The Commission has issued the enclosed Amendment No. 8, Technical Specification Change No. 18 for License No. DPR-38; Amendment No. 8, Technical Specification Change No. 13 for License No. DPR-47; and Amendment No. 5, Technical Specification Change No. 5 for License No. DPR-55, for the Oconee Nuclear Station, Units 1, 2, and 3. These amendments are in response to your request dated May 9, 1975.

AMENDMENT TO FACILITY OPERATING LICENSE

ATTACHMENT TO LICENSE AMENDMENTS

SAFETY EVALUATION BY THE OFFICE OF NUCLEAR REACTOR REGULATION

UNIT 3
OCONEE NUCLEAR STATION
Figure 3.5.2-1C3

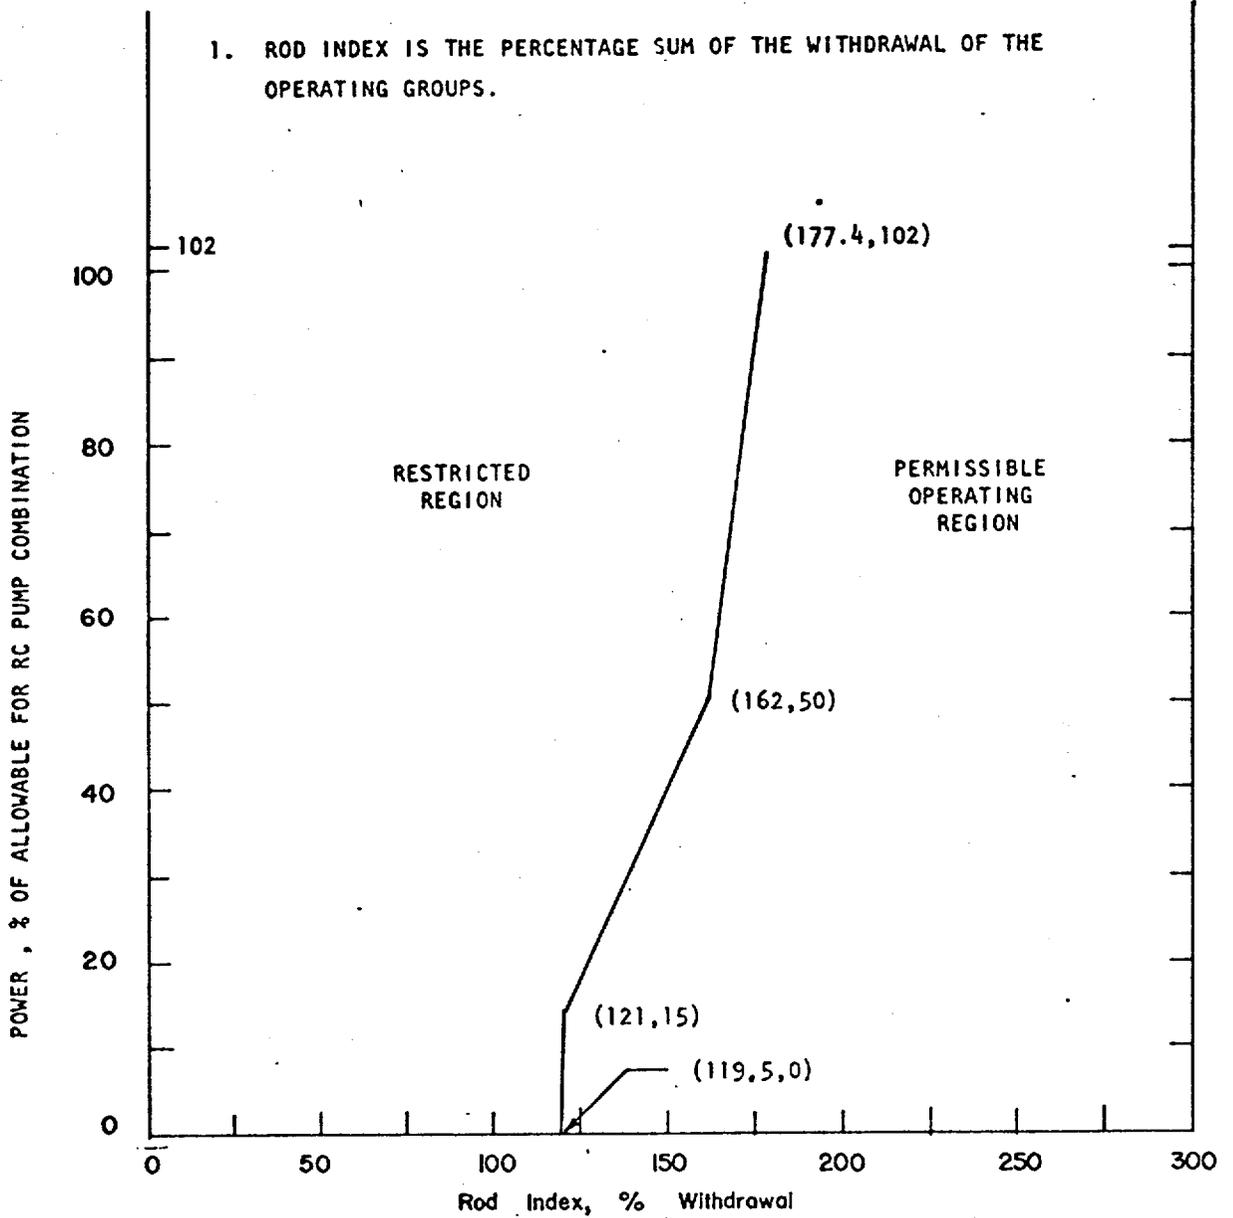
1. ROD INDEX IS THE PERCENTAGE SUM OF THE WITHDRAWAL OF THE OPERATING GROUPS.
2. THE ADDITIONAL RESTRICTIONS ON WITHDRAWAL ARE IN EFFECT AFTER 435 FULL DAYS POWER OF OPERATION.

CONTROL ROD GROUP WITHDRAWAL LIMITS
FOR 4 PUMP OPERATION UNIT 3

- b. Operating rod group overlap shall be $25\% \pm 5\%$ between two sequential groups, except for physics tests.
- c. Except for physics tests or exercising control rods, the control rod withdrawal limits* are specified on Figures 3.5.2-1A1 (Unit 1), 3.5.2-1B1, 3.5.2-1B2 and 3.5.2-1B3 (Unit 2), and 3.5.2-1C1, 3.5.2-1C2, and 3.5.2-1C3 (Unit 3) for four pump operation and on Figures 3.5.2-2A (Unit 1), 3.5.2-2B (Unit 2), and 3.5.2-2C (Unit 3) for three or two pump operation. If the control rod position limits are exceeded, corrective measures shall be taken immediately to achieve an acceptable control rod position. Acceptable control rod positions shall then be attained within two hours.
